Request for Proposals Number: 23-31

Addendum 3

Date: June 16, 2023

PROJECT: SECFEN
PROJECT NAME: Security Gate Replacement
PROJECT CODE: SECFEN
ADDRESS: Various

A101

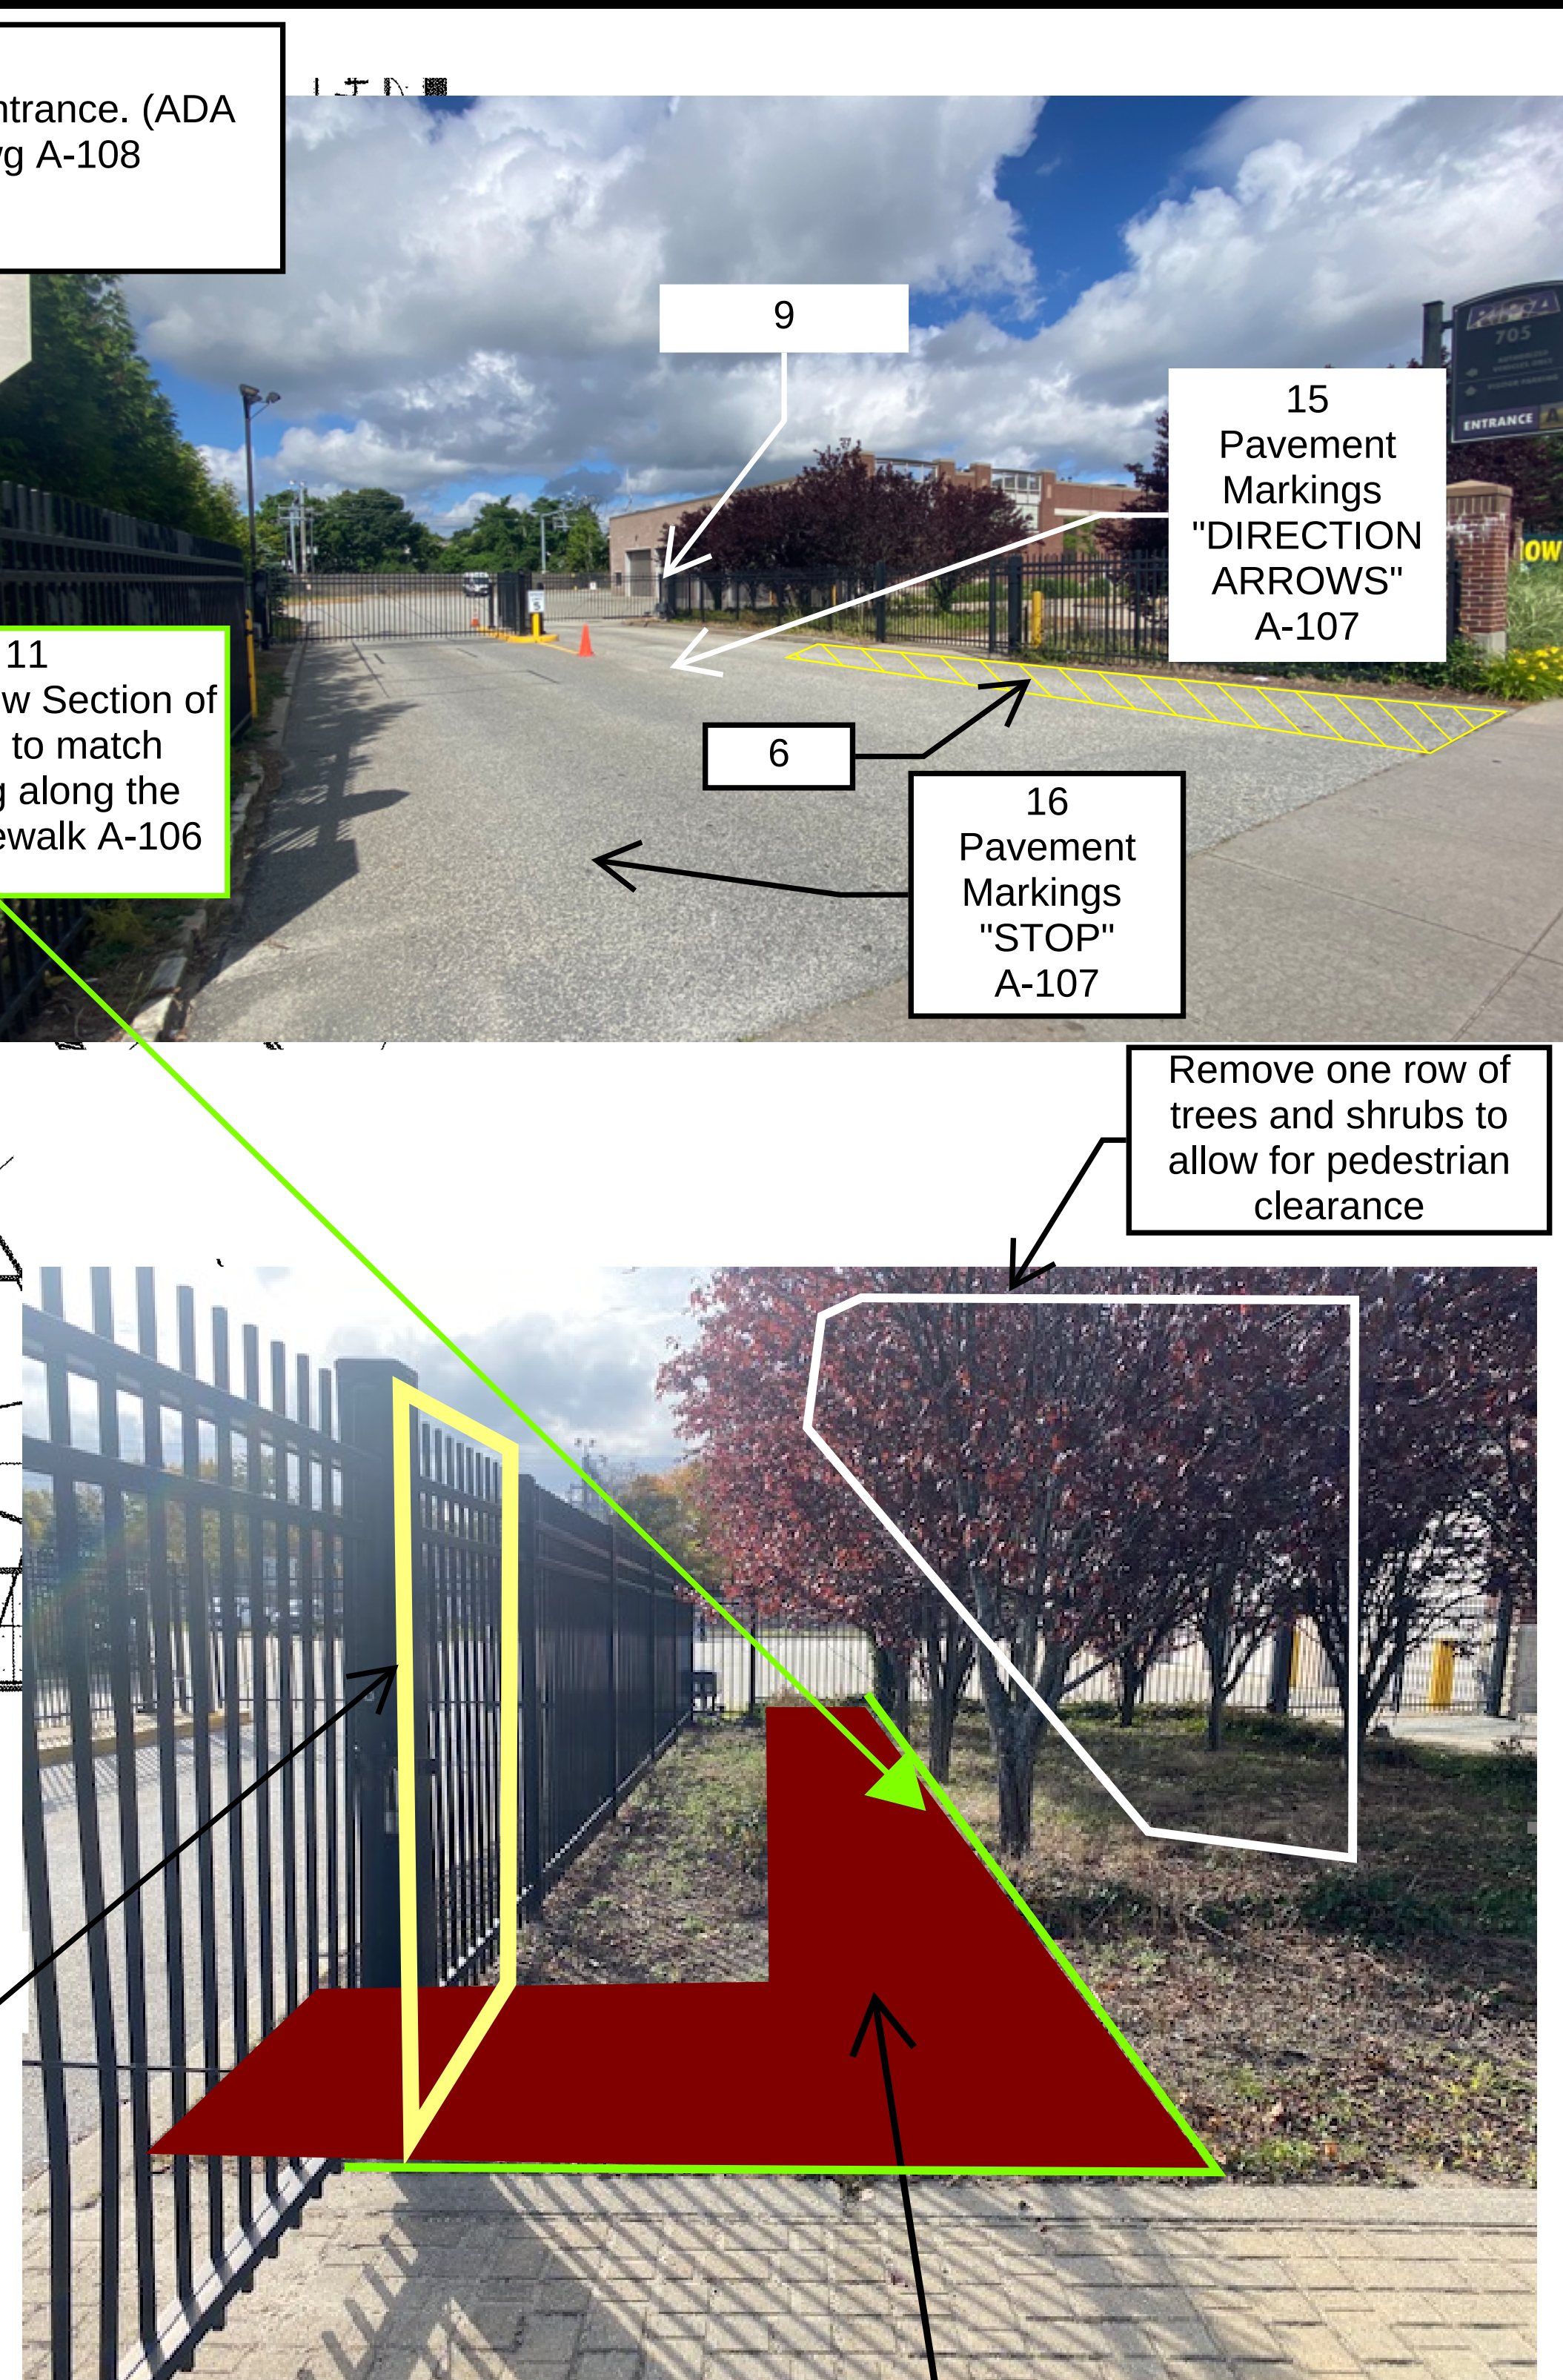
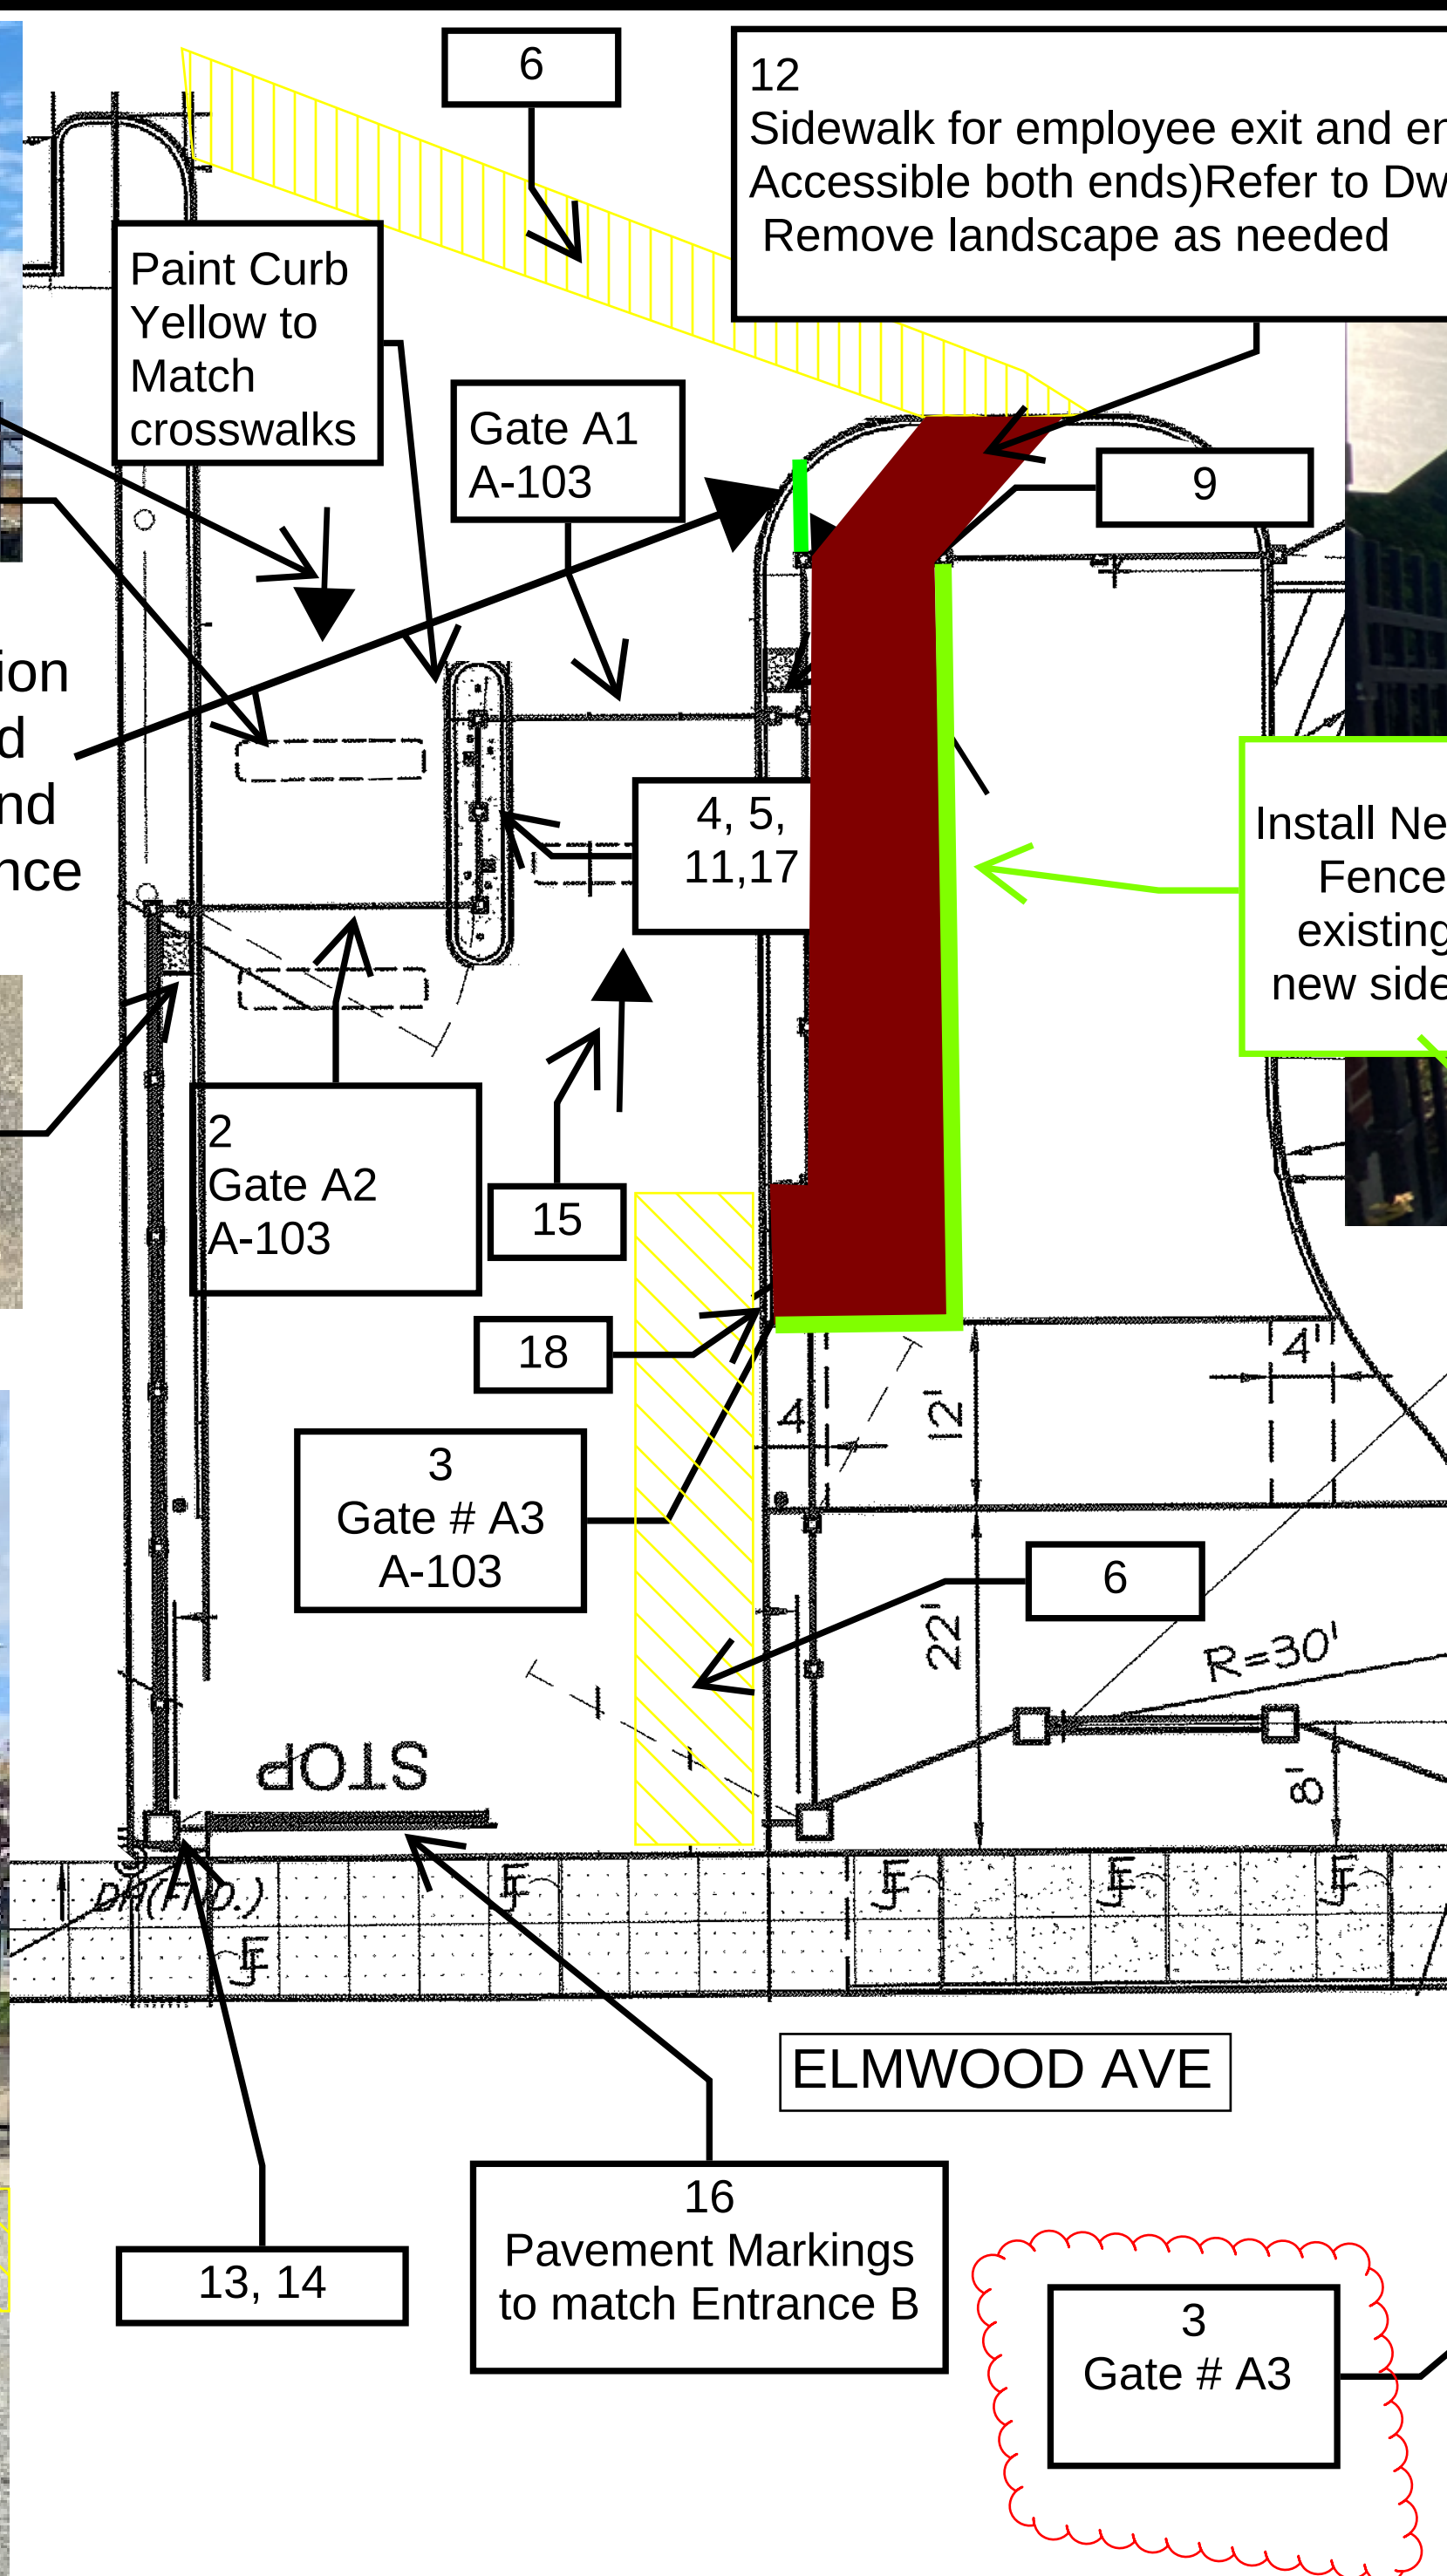
705 Elmwood Entrance	C-203	C	C7			CANTILEVER SIDE GATE DETAILS A-103	NEW	NA	X	NA	X	NA	C-203 / A-106	Relocate island (Surface mount to parking deck) and configure fencing to Widen both gates 18" - Add Security Fence to wall
				C8		CANTILEVER SIDE GATE DETAILS A-103	NEW	NA	X	X	X	NA	C-203 / A-106	
					C9	TUNE-UP Existing Pedestrian Gate	NEW	NA	X	NA	X	Tune up Exisiting Gate	C-203 / A-106	
705 Elmwood Entrance	C-204	D	D10	D10	NA	VERTICAL PIVOT GATE Details A-103	NEW	NA	X	X	YES	NA	C-204 / A-106	New Fence to match existing fence and match height of fence at corner - Remove and dispose of existing gate and footings and pave disturbed area to match existing pavement - Tie new gate into existing electrical
750 Elmwood Entrance from Elmwood	C-205	E	E11	NA	NA	CANTILEVER SIDE GATE DETAILS A-103	Tune up existing	REUSE	Reuse if structurally sound	NA	YES	NA	C-205	
750 Elmwood Exit to Elmwood	C-205	E	NA	E12		CANTILEVER SIDE GATE DETAILS A-103	Tune up existing	REUSE	Reuse if structurally sound	X	YES	NA	See Note	Replace approximately 40 posts only on perimeter Fence. Reuese and repair fencing as needed.

E13	TUNE-UP Existing Pedestrian Gate	NA	NA	NA	NA	NA	TUNE-UP Existing Pedestrian Gate	C-205	
269 Melrose Entrance / Exit to Melrose	C-206	F	F14	F14		CANTILEVER SIDE GATE DETAILS A-103	Tune up existing	REUSE	Reuse if structurally sound	X	YES		NA	Move exit loop further away from gate
					F15	TUNE-UP Existing Pedestrian Gate	NA	NA	NA	NA	NA	Tune up Exisiting Gate	NA	
Ryder Lot Entrance from Cadillac	C-207	G	G16	NA	SEE COMMENTS	CANTILEVER SIDE GATE DETAILS A-103	Tune up existing	REUSE	Reuse if structurally sound	NA	YES	See Comments	C-207	Pedestrian Gate to remain and secured by owner
Ryder Lot Exit onto Longfellow	C-208	G	NA	G17	NA	CANTILEVER SIDE GATE DETAILS A-103	Tune up existing	REUSE	Reuse if structurally sound	X	X	NA	NA	Rework sidewalk to accomodate bus turn radius
Employee Parking Lot Melrose Exit - Entrance	C-209	H	H18			CANTILEVER SIDE GATE DETAILS A-103	NEW	REUSE	NEW and Reuse existing if possible	NA	X	NA	C-209	Reconfigure Entracne / Exit so vehicles can make a safe turn thru the gates

H19		CANTILEVER SIDE GATE DETAILS A-103	NEW	NEW	NEW	X	X	NA	C-209	
					H20	RELOCATE AND TUNE-UP Existing Pedestrian Gate	NA	NA	NA	NA	NA	Relocate Pedestrian Gate H-21	C-209	
Newport Facility	C-210	I	I-21	I-21		SLIDE ENTRANCE GATE DETAILS A-103	NEW	NEW	NEW	Open 1/2 way on exit	X	NA	See note	ADD Security Fence from new gate to existing Security Fence - One Slide Gate with new support posts. (do not remove existing support poles) Gate to be moved in towards the building approximately 4' (tbd) - OPEN HALLE WAY ON EXIT
					I22	2150 Style Pedestrian Swing	NA	NA	NA	NA	NA	2150 Style Pedestrian Swing	See Note	Add 8' wide Utility Gate (2) 4' swing gates
